SP 8-505-004

SERVICE PROGRAM

ACTT Rear Sliding Door Backing Plate Installation.

This Service Program provides information regarding the installation of a backing plate for the rear sliding door.

Figure 4

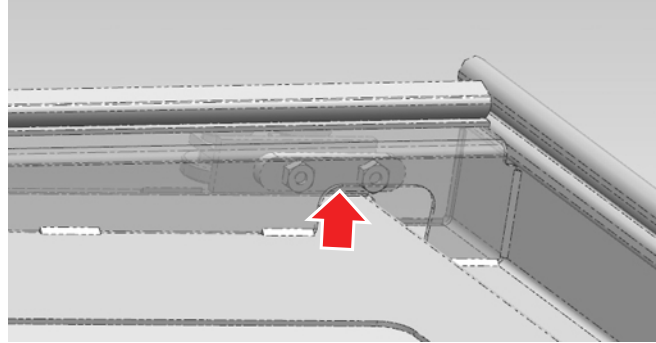
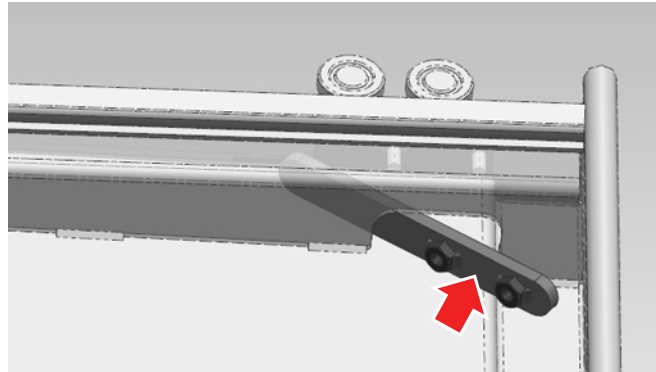
6. Remove both of the current backing plates for the cab door wheels and discard (see Figure 4).
7. Utilizing flat washers (322357) and bolts (9X2046), install both of the new backing plates (A518012-001) and the door wheels that were set aside in step 5 into sliding door (see Figure 5).
